## Certified Action of the City of Raleigh Planning Commission

**Case File / Name:** SP-37-11 / North Carolina Rate Bureau

**Nature of Case:** The recombination of three parcels into one parcel and the construction of a two-story 26,139 square foot office building on 3.35 acres, zoned Thoroughfare District CUD, inside the city limits.

## Staff Report

SP-37-11 North Carolina Rate Bureau – Site Plan

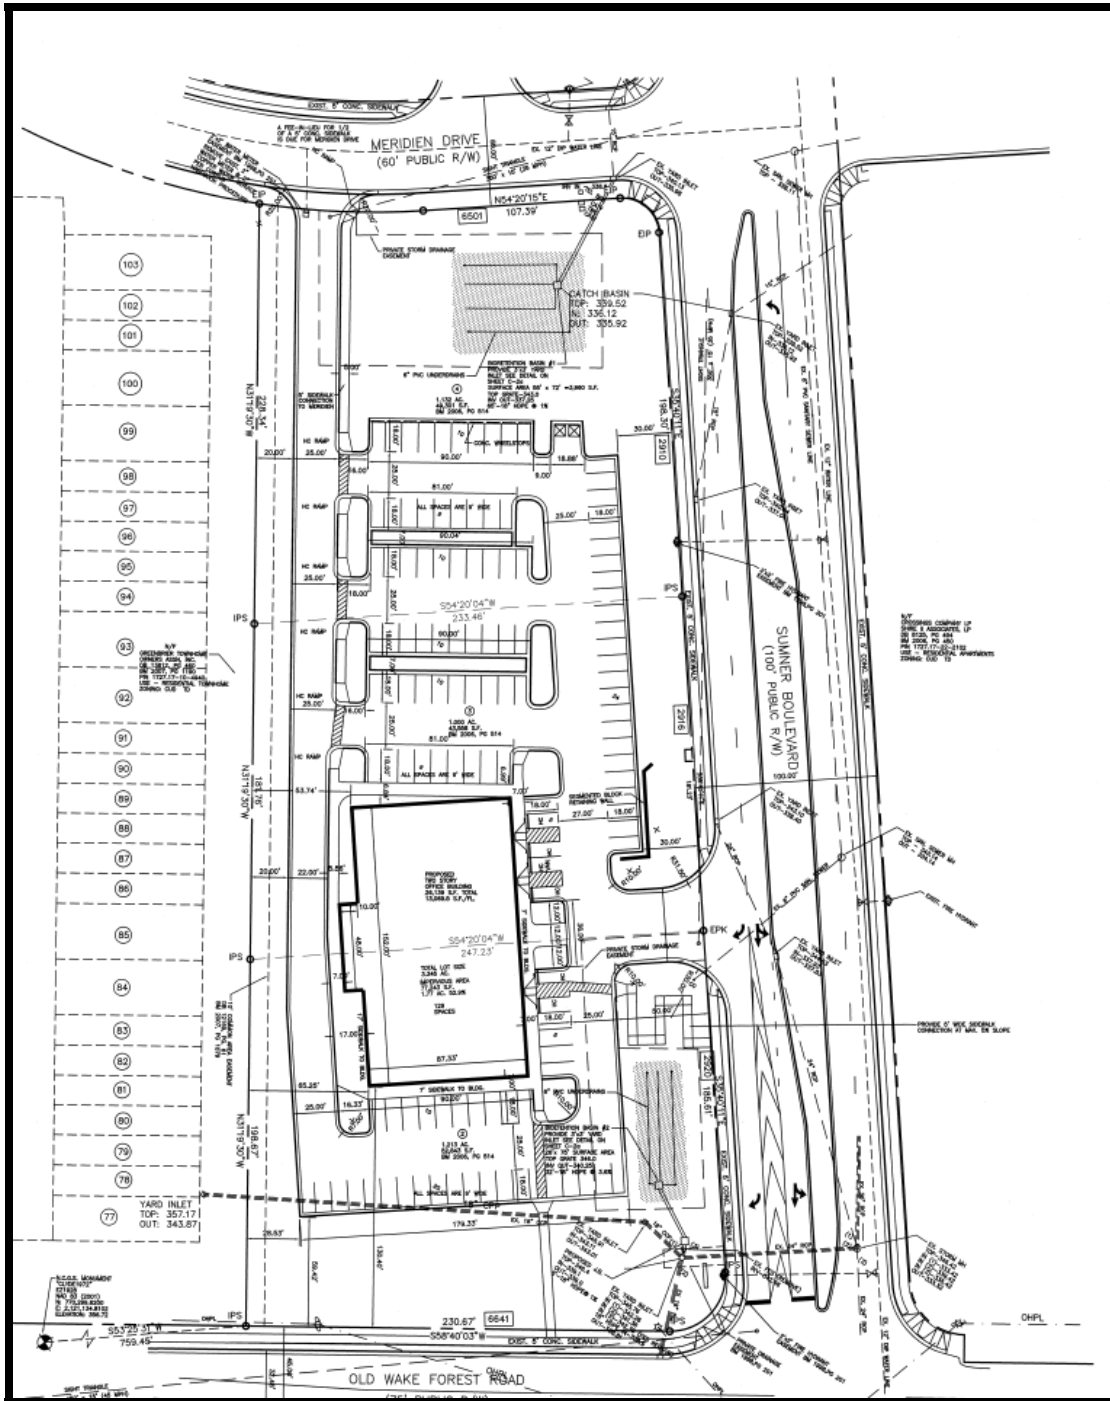
- (7) That a revised landscape plan be submitted to the City showing an average 50' thoroughfare yard with a minimum width dimension of 35 feet along Sumner Boulevard; and

<u>Comment</u>	<u>Response</u>
1) Given the mixed performance of red maples in similar local developments, the Committee recommends a different shade tree species be substituted [commensurate with Code Sec. 10-2132.2(d)(4)].	I have not seen any problem with the hybrid "October Glory" red maples. I have looked around town since I received this comment and can find no problems with red maples unless they are in tree grates in the downtown area. I don't have that many on this plan. I

- 2) Additionally, rather than a monoculture of ligustrum, integrate other evergreen shrub species into buffer plantings [commensurate with Code Sec. 10-2132.2(d)(2)].  
 also checkek with NCSU to see if they have published any problem finding and cannot find any problems. Therefore I will keep the red maples on this plan. I respectfully decline to change this species of plant or to mix other varieties.
- 3) To reduce light spillover onto the immediately adjacent residential properties, locate site light poles away from shared/ nearby property lines and cap footcandle outputs at their lowest effective levels [commensurate with Code Sec. 10-2132.2(d)(2) & (4)].  
 I have asked Progress Energy to do a lighting plan and to keep the lighting along the rear driveway at a minimum.
